D/DRC Case

522 Lady Street

**DESIGN/DEVELOPMENT REVIEW COMMISSION
DESIGN REVIEW DISTRICT
EVALUATION SHEET
Case # 6**

NATURE OF REQUEST: Request Certificate of Design Approval for exterior changes and preliminary certification for the Bailey Bill

Enlarged Site Plan

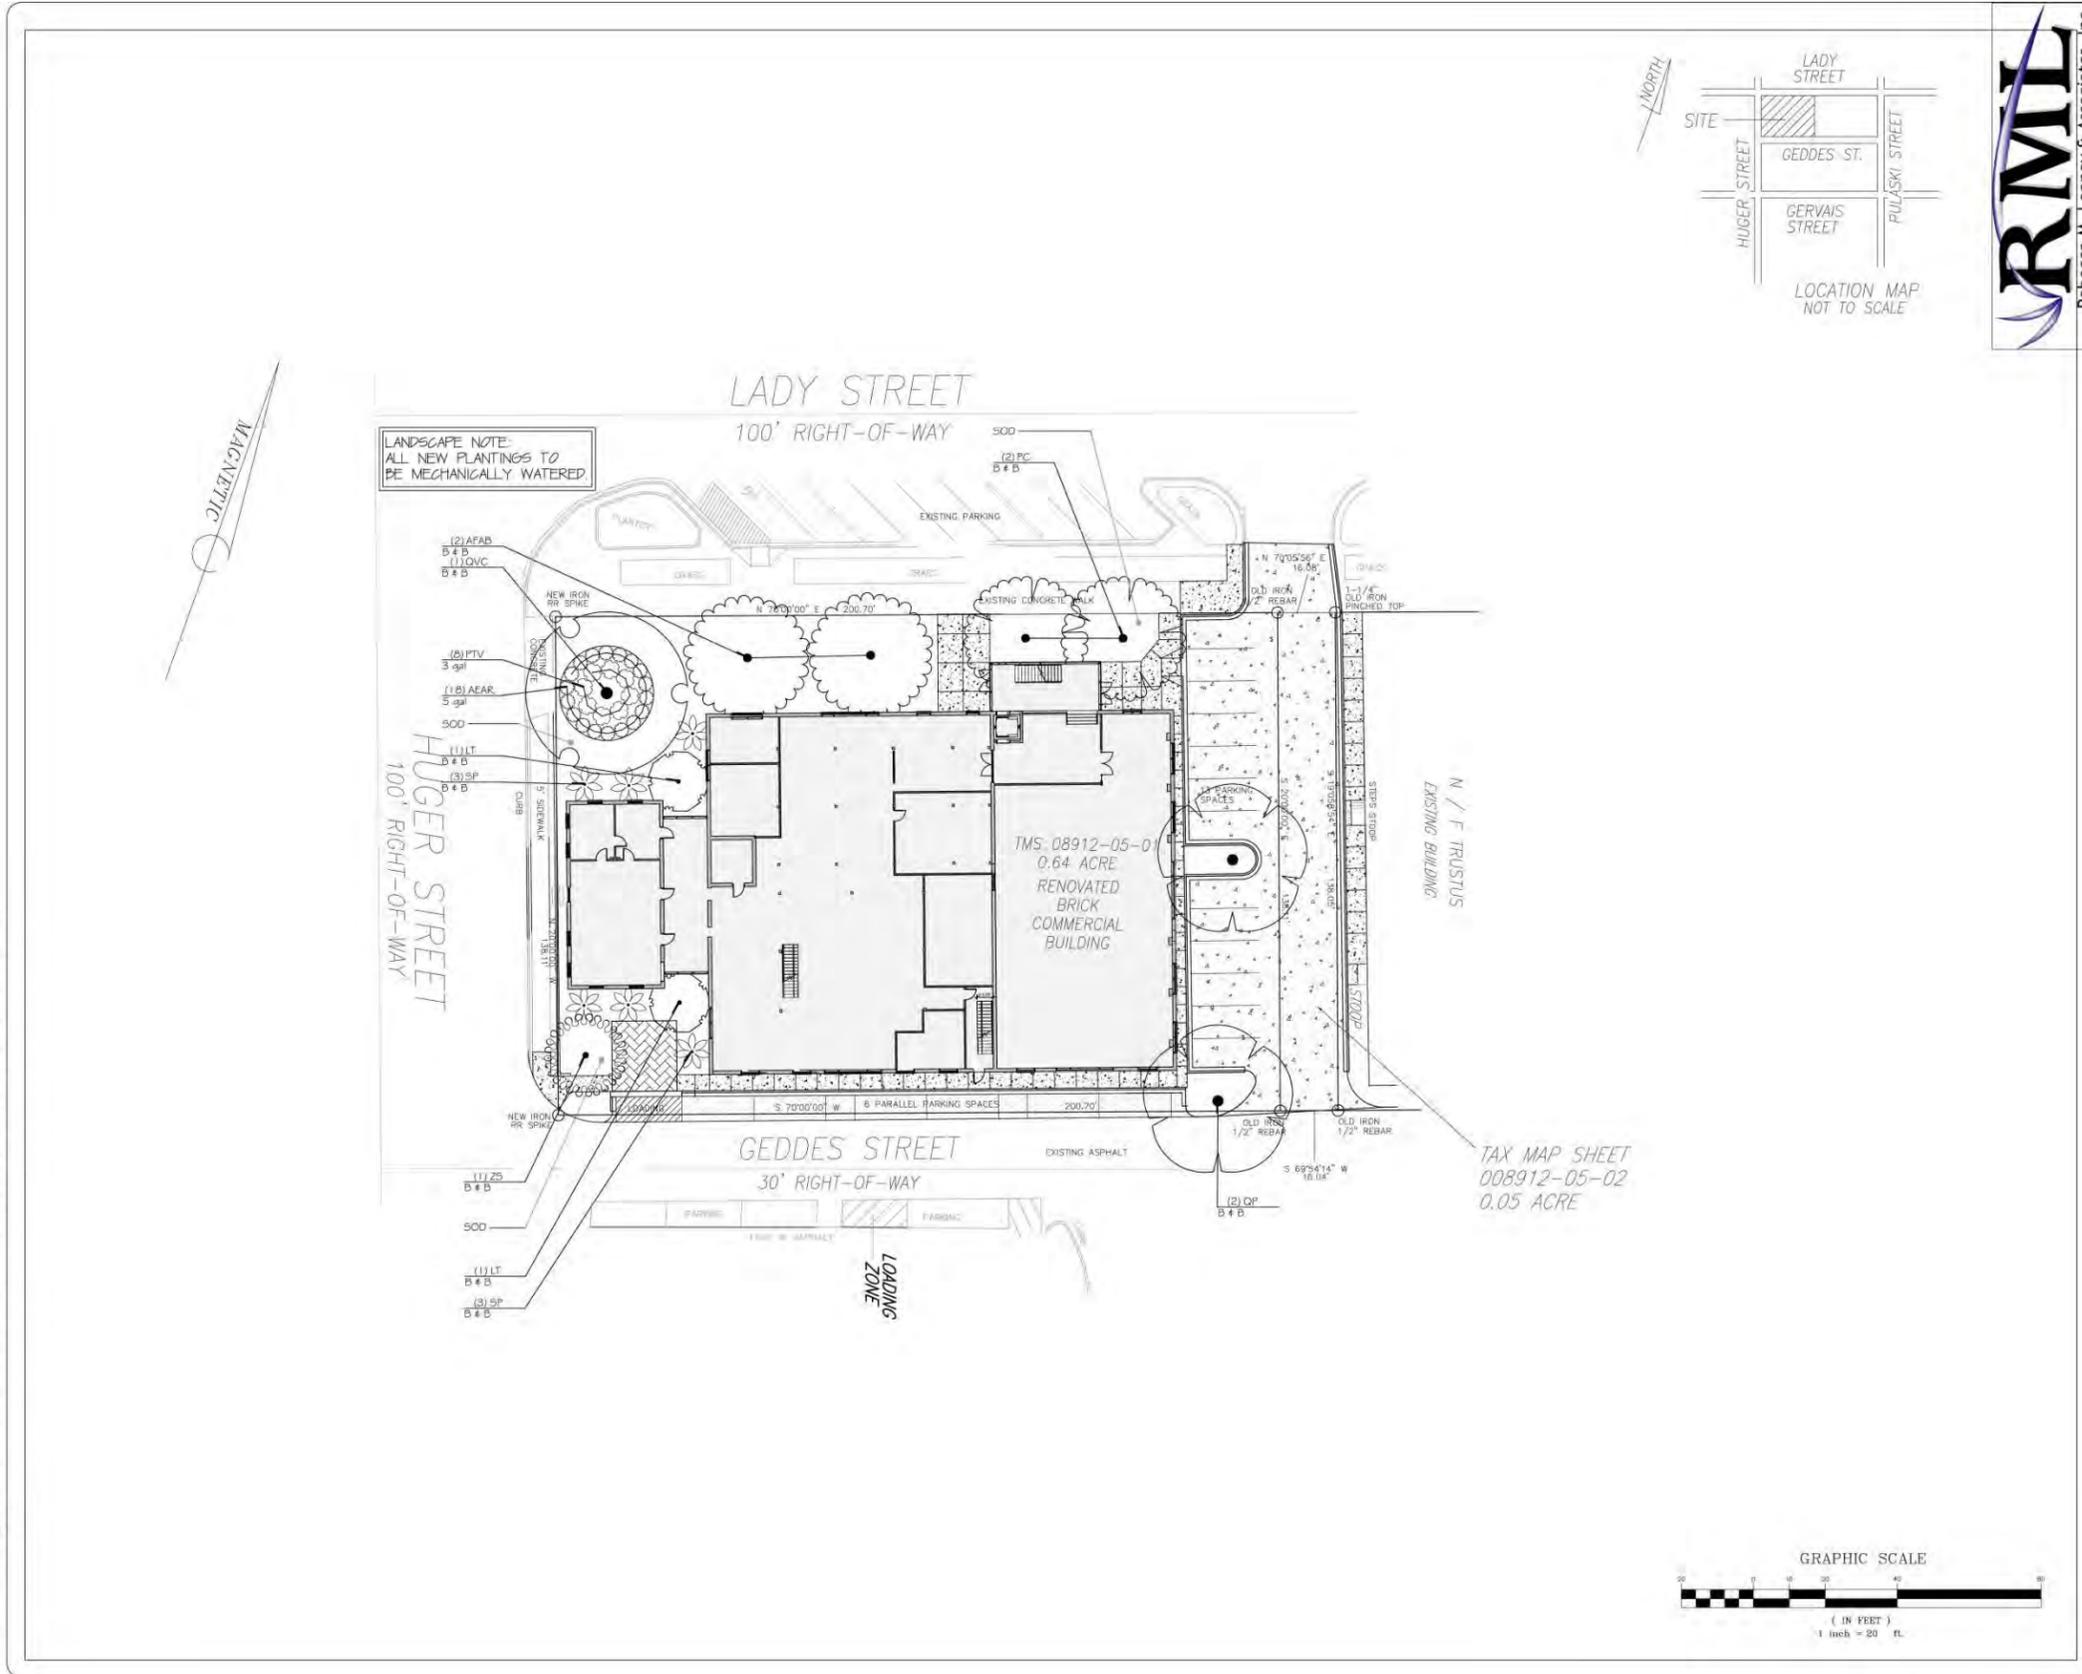
Site improvements may be approved at staff level but are included here. Parking is handled at the rear of the lot, facing Trustus, with additional spaces along the alley on Geddes Street. The City's Land Development Planner is satisfied with the site plan with the exception that screening hedges need to be installed near parking spaces. This would mean screening hedges at either end of the parallel parking spaces on Geddes Street as well as hedges on either end of the spaces at the rear of the building. Additionally, some encroachments may be required. Staff is happy to work out details with the applicants. Landscaping requirements within the City's Design District are also listed below for consideration:

Street trees as shown on the landscape plan seem to be adequate per the guidelines with the exception of Geddes Street where a shade tree placed in the center of the row of parallel spaces there would comply with the requirement of a shade tree within 40' of every parking space (suggest combining the two "paved" areas between some of the parallel spaces into one planting space, although this will be less than standard planting space for the tree.)

Hedges should be installed as mentioned previously and per the Land Development Planner. An evergreen hedge or low masonry wall (30-36" tall) is needed to screen the row of parking that runs perpendicular to Gervais (to screen this row from Gervais);

Screening as above for the same row of parking at south end of the row to screen parking from Geddes;

Screening on the east end of the parallel parking row to screen these from Huger.

This is an option for the applicants along Lady Street.

The plan appears to meet this requirement.

Some small screening may be needed for the loading area indicated on the southwest portion of the lot. Staff is happy to work out details with the applicant.

Hedges meeting the landscape ordinance will be installed as needed and as described near each parking area; one shade tree along Geddes will be required with details to be worked out with the Land Development Planner;

1 North Elevation
SCALE:

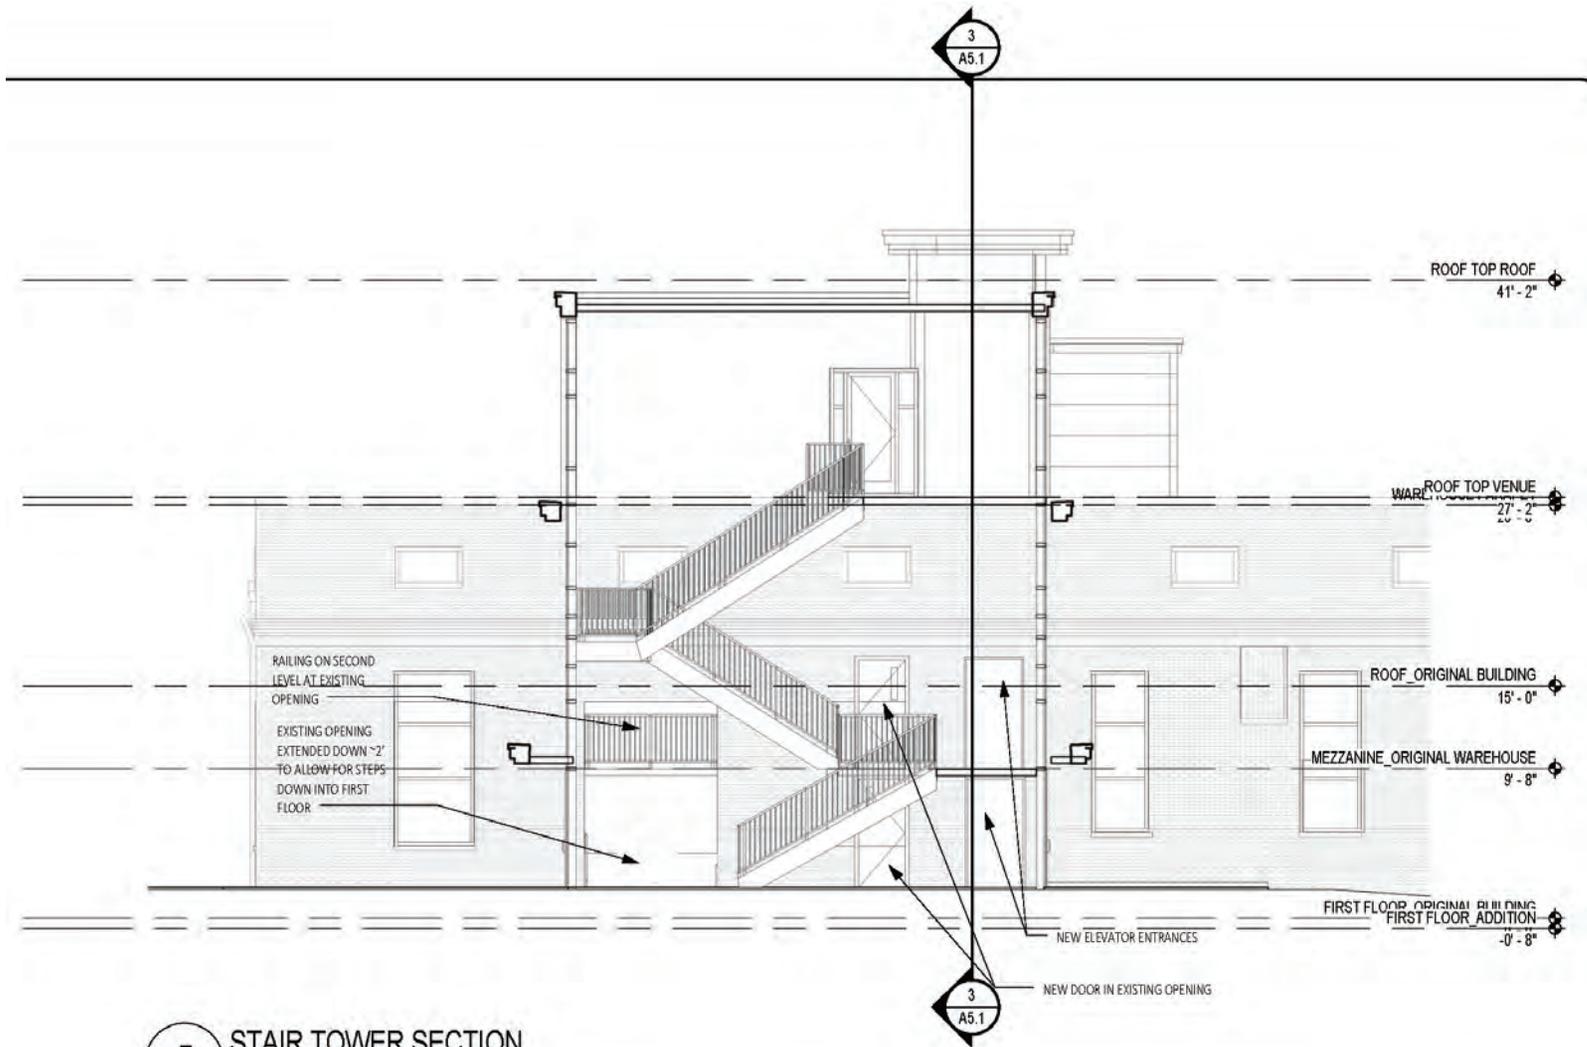
This elevation of the large warehouse building is another primary elevation since it fronts Lady Street. As one can tell from the photographs of existing elevations, many openings have either been cut in and/or filled in over time. There are large warehouse openings which may or may not be original and which have been bricked in, inconsistent window sizes and location, some extant window sills (although irregular in placement) and so on. It is likely that as various owners' needs changed, they adapted the building's openings to accommodate, with little attention paid to consistency of architecture. There is some consistent detailing in the upper part of the building, the cornice area, as well as a running bond pattern immediately below. As stated earlier, there are no photographs of this building originally so the window configuration is in question, although metal windows were common for this type of building and this time period. The window configuration may have been quite simple or may have been some configuration of fixed panels with awning windows which opened in, and so on. New windows therefore could be aluminum clad but should certainly avoid a typical storefront feel, so the profiling and dimensions of muntins will be important. Staff is continuing to explore what would be appropriate and is comfortable working out the details with the applicants if the DDRC approves.

Toward Huger, the smaller front office building will show original window openings re-established and existing details maintained. The connection between this building and the larger warehouse building will also be re-created by way of a glass hyphen. This feature will be visible since the later concrete block additions will be removed. The hyphen is appropriately inset in terms of both height and width and will clearly be a new feature although compatible. The new construction meets #7 as stated of the Bailey Bill Criteria:

Along the main warehouse building, the architect has proposed full size windows where there were bricked-in large windows or smaller windows, whose width has been kept but whose height has been raised to match the others. There are some smaller windows which align just under the running bond pattern which have been bricked in too; there are no plans to re-open these but they will remain as is. A new window was originally proposed at the front right corner of this elevation, toward Huger Street, where the original brick does not reflect any previous openings. Staff therefore does not recommend for this particular window, since this is another primary elevation and the introduction of an opening where there was none at all changes the understanding of the original building. A larger bricked-in opening along this wall, which perhaps functioned as a loading dock, will be re-established as a large window. Again, the design of this is still to be determined but staff is comfortable working out the configuration with the applicants.

The entry on Lady Street is a prominent addition to the building. As this building fronts two streets, the owners found an entry on this street would be a more accessible point for employees and clients than Huger Street. The entry is a large glass and anodized aluminum panel curtain wall which encloses a required egress stair which allows access to ground, mezzanine, and rooftop offices. The effort here was to make a transparent entry, allowing the basic form of the building to be read, while introducing a new contemporary element (see #7 & 8 of Criteria). At rooftop, the stair tower extends out as an addition which incorporates a conference room and outdoor area. A small stair tower (for egress) is also included toward the south side of the roof. The buildings at rooftop are glass and aluminum composite metal panel. Like the entry, the glass will be insulated and almost clear in appearance.

The new entry is constructed so as to allow the original building underneath to be understood. One opening is proposed at the mezzanine level for an entry there but falls within an existing bricked-in opening; otherwise, other existing openings will either be left as is or will be un-bricked and re-used.

The new entry is streamlined and simple and uses materials that clearly differentiate it from the original building. The use of glass as a major element helps to diminish the size; another option would be to forego the aluminum panels entirely on the corners and simply use glass.

Staff continues to work with the applicants on the correct window configuration for the warehouse section of the building as well as details on the front door facing Huger Street;
